Work Order ID 101702

Item Name: Crosstube Fwd High

DART AEROSPACE LTD	Work Order:	101702
Description: Crosstube High Fwd (205/212/412)	Part Number:	D212-664-101
Inspection Dwg: D212-664-141 Rev: D		Page 1 of 1

DRAWING NO. D212-664-141	TITLE XTUBE ASSY (205/212/412 HI FWD)	REV. D	DART AEROSPACE LTD ENGINEERING ORDER		D.E.O. NO. D212-664-141-D-1	SHEET NO. SHEET 1 OF 2	SCALE NTS
DRAWN	CHECKED	MFG. APPR.	APPROVED	DE APPR.			
DATE 11.04.07	DATE 11.09.11	DATE 11.04.12	DATE 11/04/12	DATE 11.04.12

**D212-664-141/-141B
ASSEMBLY DETAIL**

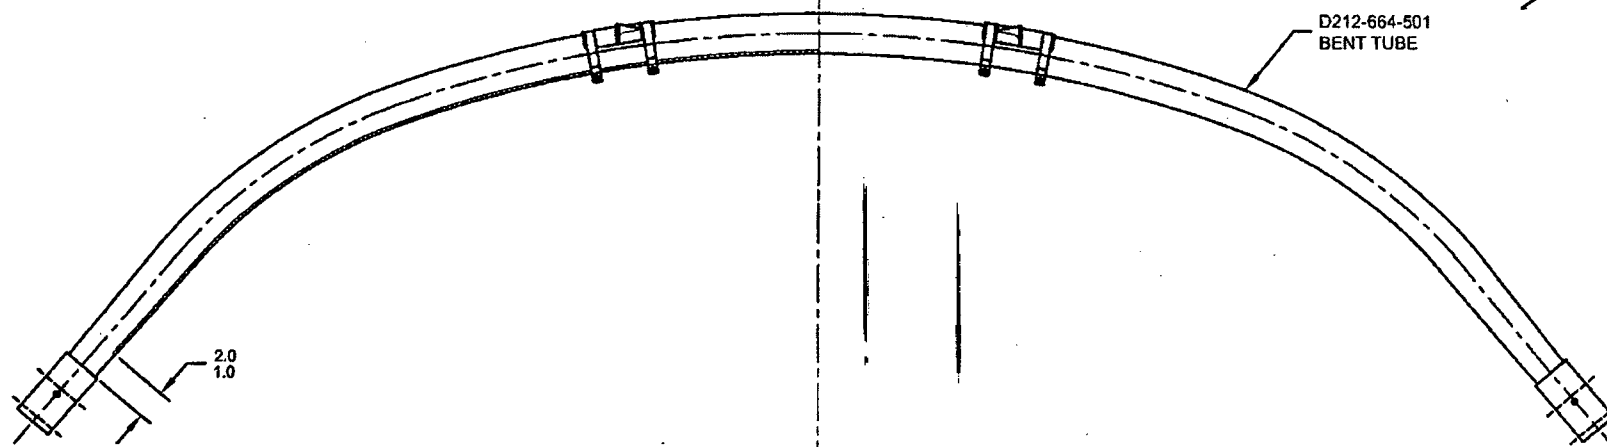
PURPOSE:

ADD AN INSPECTION WINDOW TO UNDERSIDE OF CROSSTUBE.

IS:

WAS:

MASK AREA PRIOR TO PAINTING,
REMOVE MASKING AFTER PAINT
AND APPLY CLEAR COAT
